Introduction of the new SAF-HOLLAND self-setting automatic slack adjuster from 1st February 2015

SAF-HOLLAND has adapted the new self-setting, fully automatic slack-adjuster for use with the SAF INTRADRUM rigid axle.

From February 2015, it will be fitted as standard on drum brake SNK 420x180.

Fig. 4: New type plate with data mat

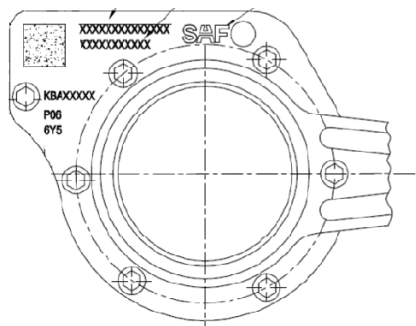
Another feature that is different is the new type plate with data matrix code and SAF logo.
